**GENOA CHARTER TOWNSHIP
PLANNING COMMISSION PUBLIC HEARING
SPECIAL MEETING
JUNE 24, 2019
6:30 P.M.
AGENDA**

OPEN PUBLIC HEARING #1...Review of a special use, site plan and environmental impact assessment for a proposed 60,335 sq. ft. industrial building located at 5665 Sterling Drive, Brighton. The request is petitioned by Schonsheck, Inc.

| Subject: | Masonite Corporation – Special Land Use and Site Plan Review #2 |

Re: Masonite Corporation Site Plan Review No. 2

PROPOSED ADDITION PLAN

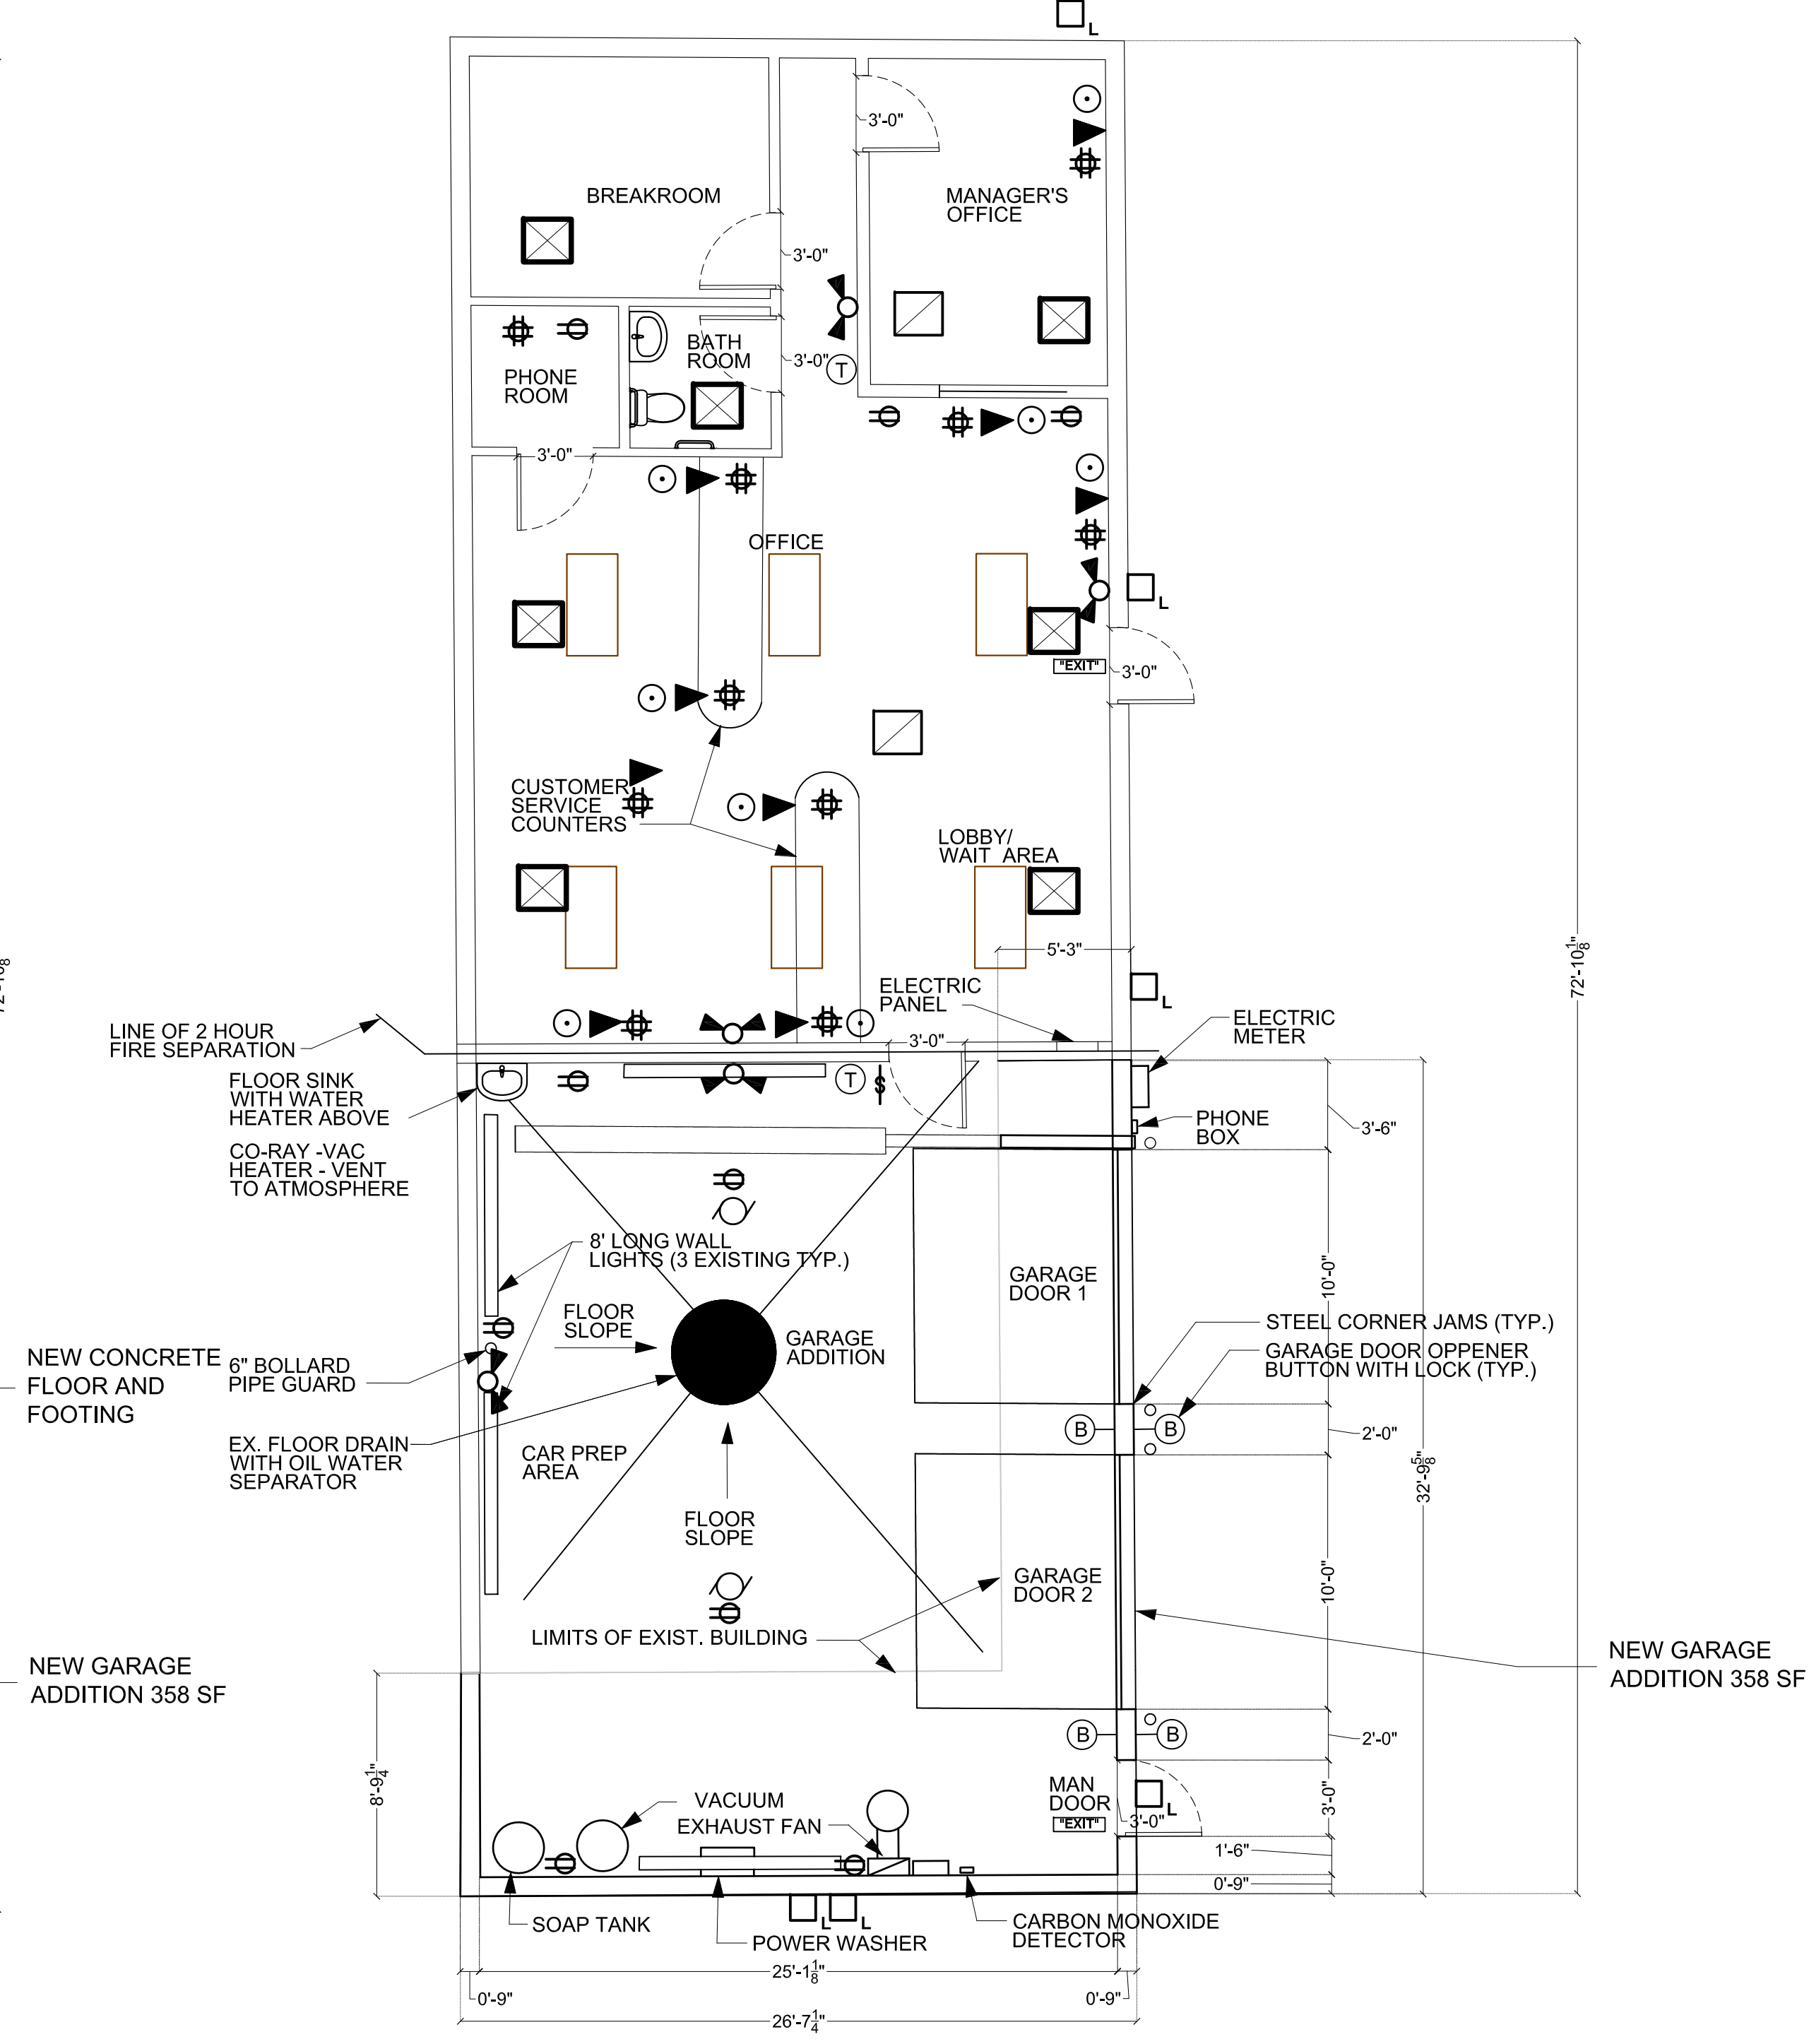
There is a minor inconsistency in the submittal with respect to the size of the proposed addition. More specifically, Sheet A2.0 notes a 358 square foot addition, while Sheet C2.0 describes it as 308 square feet. This discrepancy must be corrected.

- 1. Size of the Proposed Addition** – The size of the additions on Sheet A2.0 and C2.0 does not match.

Response: The size of the additions on Sheet C2.0 has been revised to 358 SF to match A2.0.
